Work Order ID 102240

Item Name: Crosstube Fwd

DRAWING NO. D407-667-145	TITLE CROSSTUBE ASS'Y (407 HIGH FWD)	REV. C	DART AEROSPACE LTD ENGINEERING ORDER		D.E.O. NO. D407-667-145-C-1	SHEET NO. SHEET 1 OF 1	SCALE NTS
DRAWN 97	CHECKED ASS	MFG. APPR. 18	APPROVED WD		DE APPR. H		
DATE 11.07.15	DATE 11.07.22	DATE 11.07.22	DATE 11/07/22		DATE 11.07.21

DRAWING NO. D407-667-145	TITLE CROSSTUBE ASS'Y (407 HIGH FWD)	REV. C	DART AEROSPACE LTD ENGINEERING ORDER	D.E.O. NO. D407-667-145-C-2	SHEET NO. SHEET 1 OF 1	SCALE NTS
DRAWN AJS	CHECKED	MFG. APPR.	APPROVED	DE APPR.		
DATE 12.08.02	DATE 12.08.02	DATE 12.08.02	DATE 12.08.02	DATE 12.08.02	DATE 12.08.02

DETAIL P
BONDING STRAP INSTALLATION 2 PL

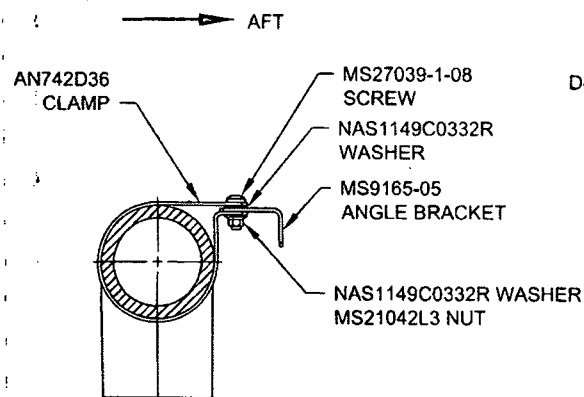
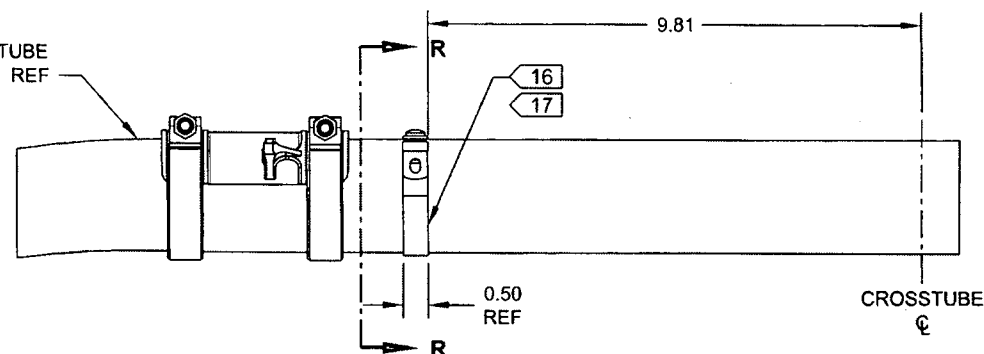
ADD ELECTRICAL GROUNDING STRAP

ITEM	QTY -145	PART NUMBER	DESCRIPTION
1	X	D407-667-145	CROSSTUBE ASSEMBLY (407 HIGH FWD)
10	2	AN742D36	CLAMP
11	2	MS9165-05	ANGLE BRACKET
12	2	MS21042L3	NUT (OR MS21042-3)
13	2	MS27039-1-08	SCREW
14	4	NAS1149C0332R	WASHER (OR AN960C10L)
